TOWN OF WATERTOWN

**Contract Number: 614.8
Chiller Replacement
Watertown Town Hall
149 Main Street,
Watertown, MA 02472**

ADDENDUM NO. 1
AUGUST 11, 2021

NOTES:

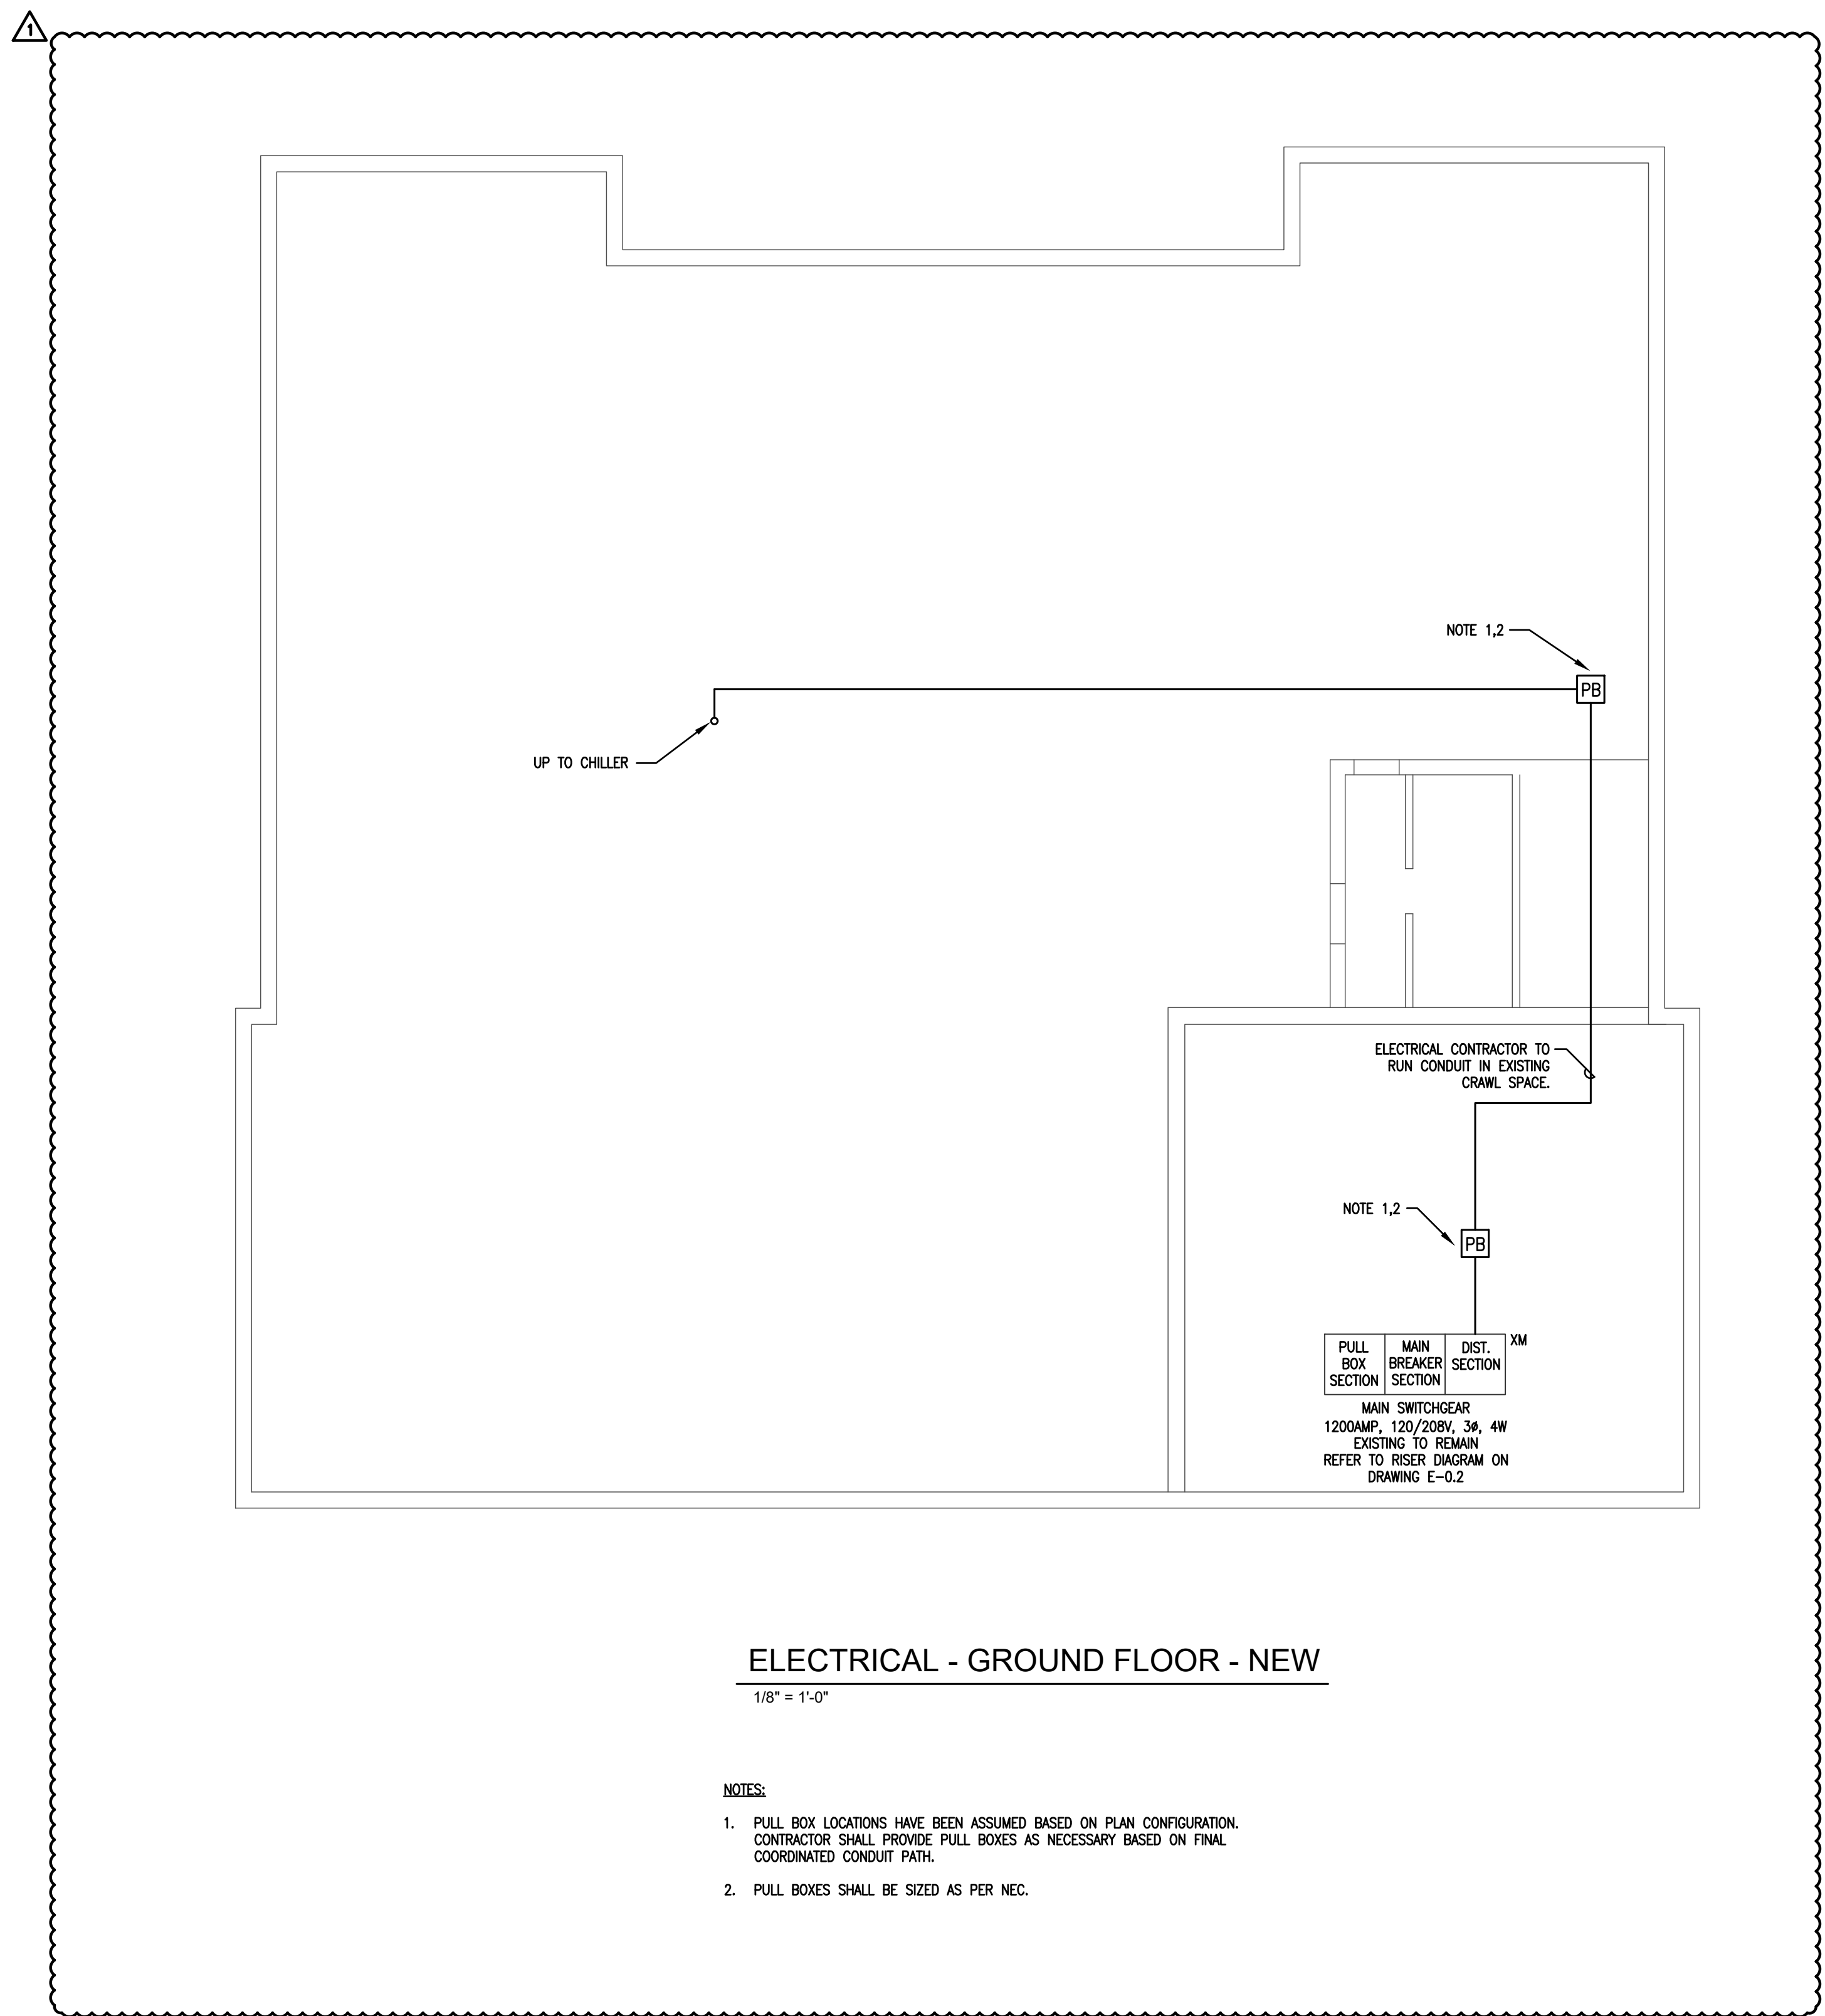
- 5.1. REPLACE Electrical Sheet E1.0 with the attached Electrical Sheet E1.0 Revision 1 dated 8/6/21.
